Maury Street Streetscape Phase 2

Urban Design Committee Meeting

Revised for Final UDC December 11, 2025 (slide 20)

UDC Recommendations and Responses

Revised Commerce to 7th

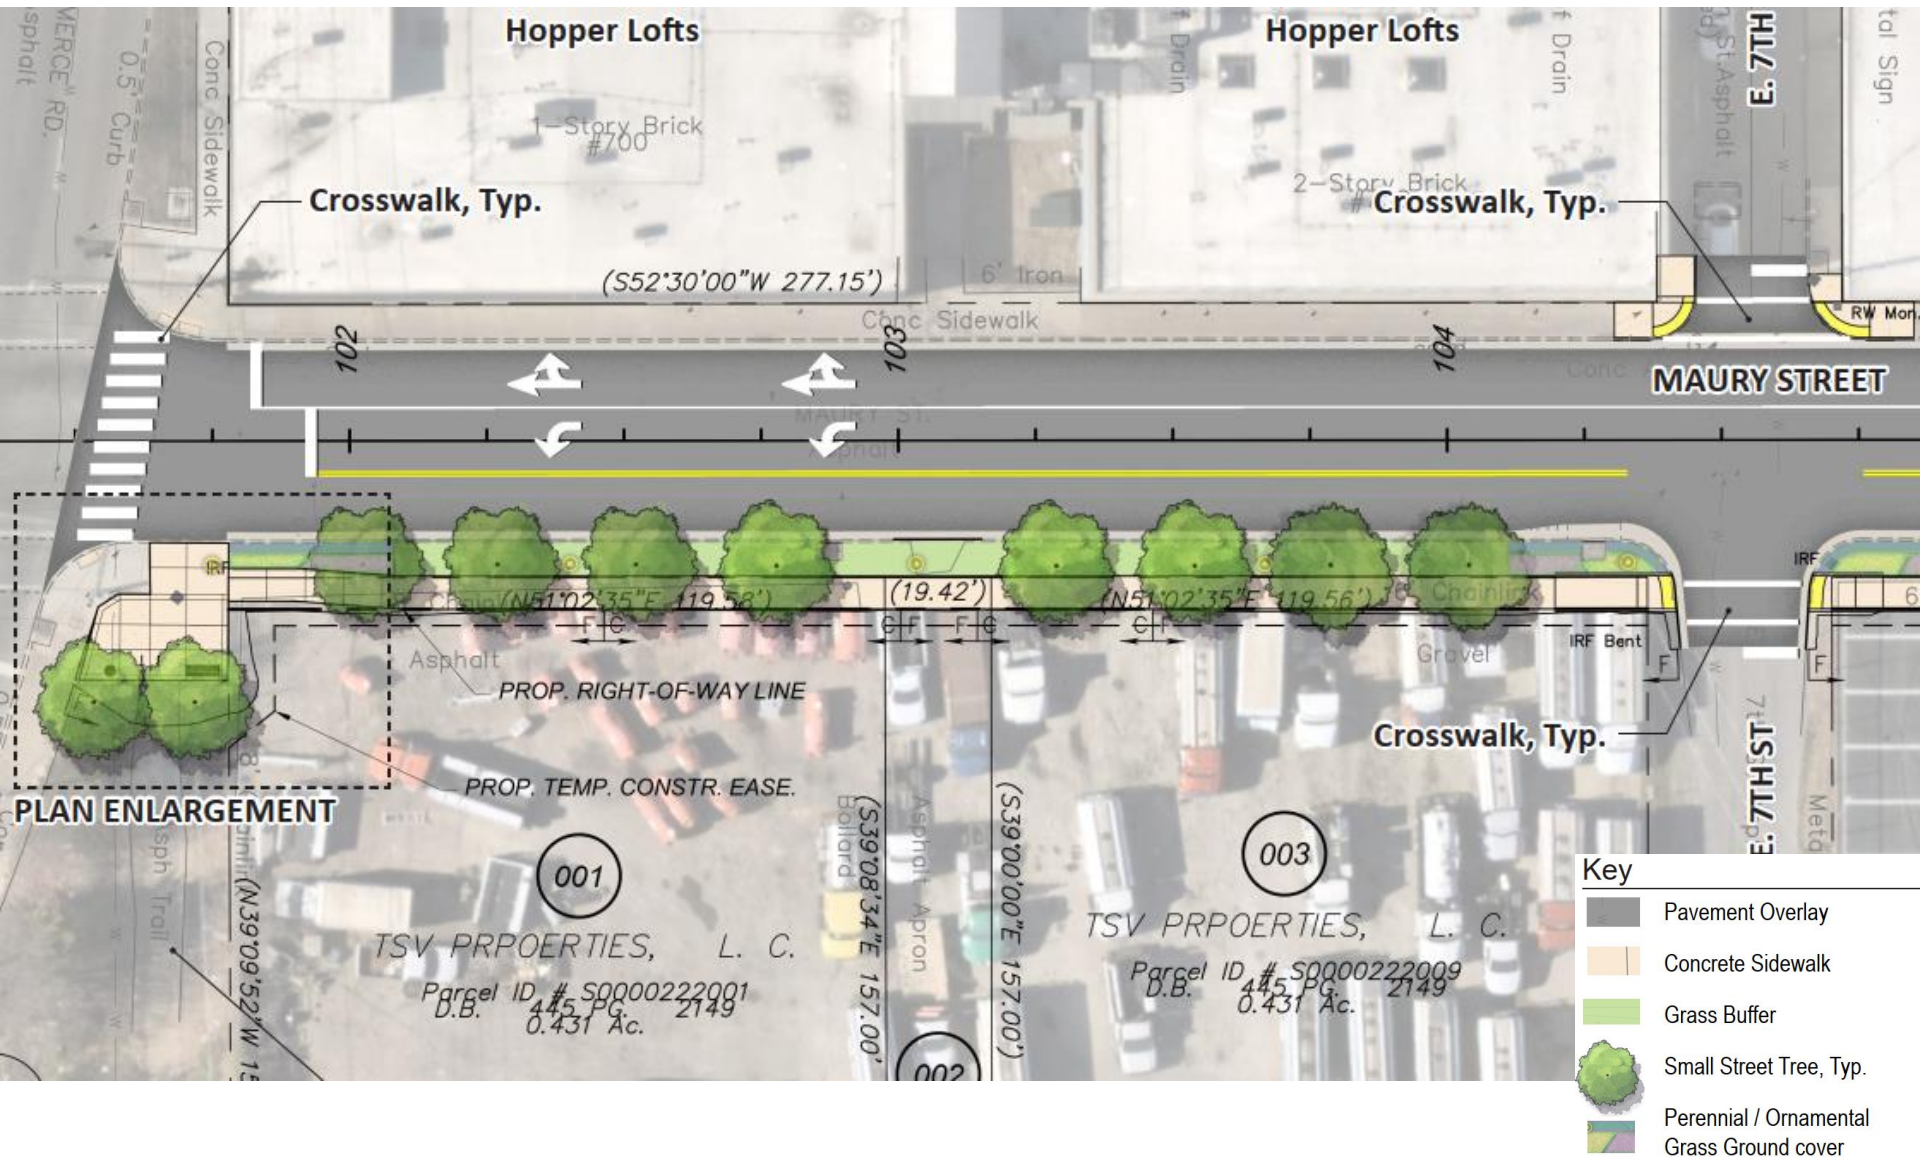
1. Applicant to evaluate street tree spacing and select appropriate native species for inclusion in the final landscape plan submission.
 - A. Street tree species were specified by City Urban Forestry because the selected species have vertical root systems suited to the underground stormwater management system. The three species are proposed to be randomly placed. The spacing will be regular; however, proximity to existing utility poles and future light poles require the spacing to be adjusted. Final spacing includes shifted tree locations and gaps to accommodate this infrastructure.

- B. Low-maintenance native ground cover species have been added for portions of the buffer strip area in lieu of standard grass mix.
2. Applicant to assess alternative material options for use at intersections.

6th Street to 5th Street

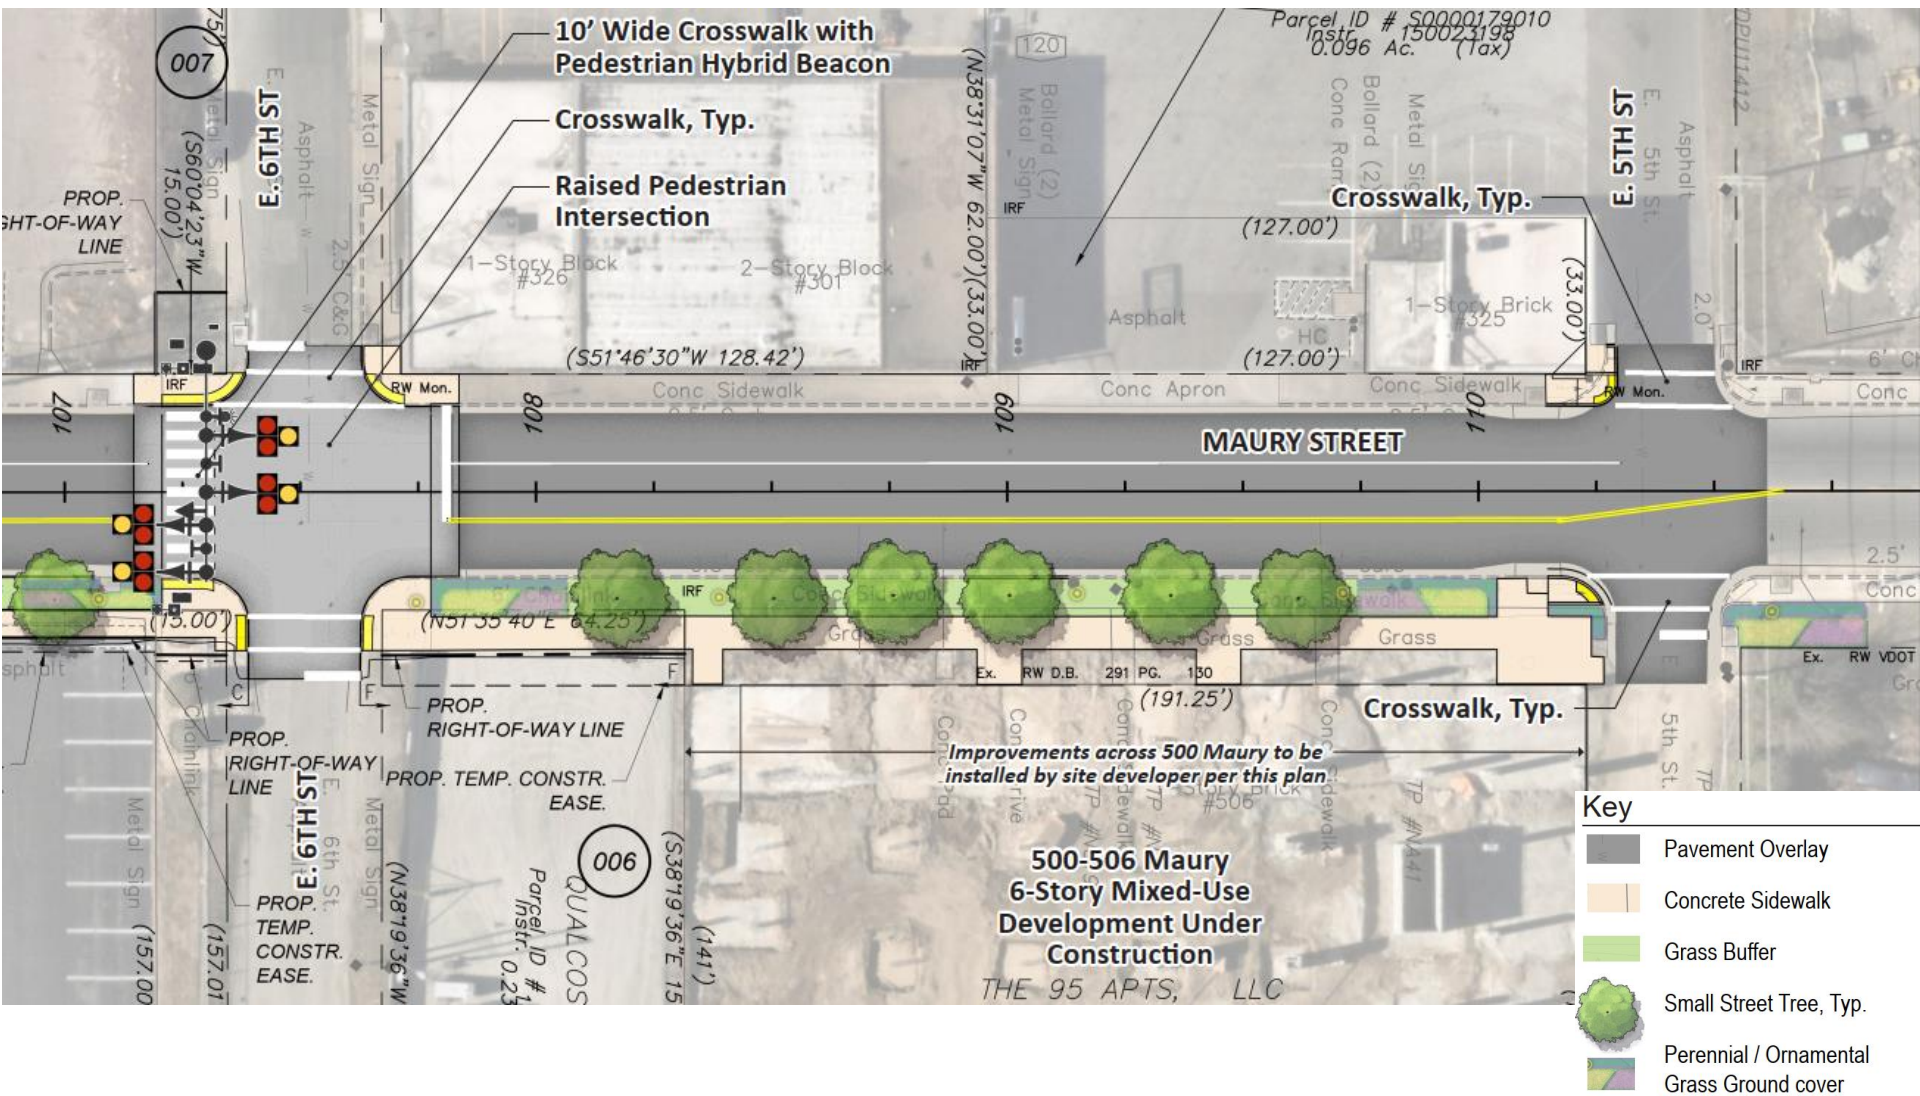
3. Applicant to consider revising the 5th Street intersection crosswalk to be aligned perpendicular to the roadway rather than diagonal.
 - A. This crosswalk has been aligned perpendicular to 5th Street.

Recommendation 3 – Parallel 5th St. Crosswalk
